**CERTIFICATE OF APPROPRIATENESS**

**Property:** 1115 E 14<sup>th</sup> Street, Lot 17, Block 117, Norhill Neighborhood Subdivision.  
The property includes a historic 1,140 square foot, one-story wood single-family residence situated on a 5,000 square foot (50' x 100') interior lot.

**Proposal:** Alteration: Windows

Photos Provided by Staff #s 107 & 108

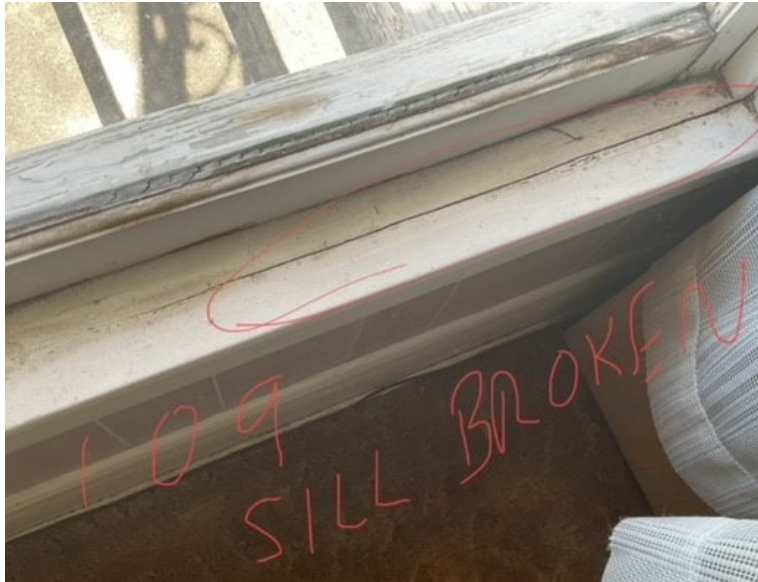
Windows  
107-108 are  
in repairable  
condition

Photos Provided by Staff #s 111 & 112

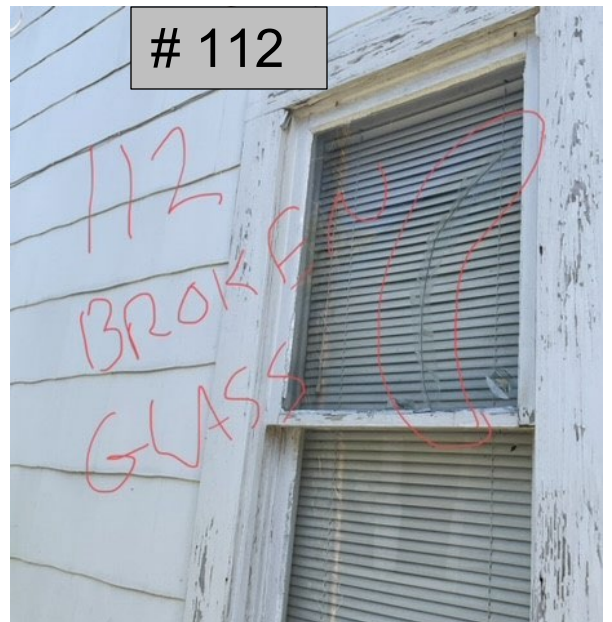
Windows 111 &  
112 are in  
reparable condition
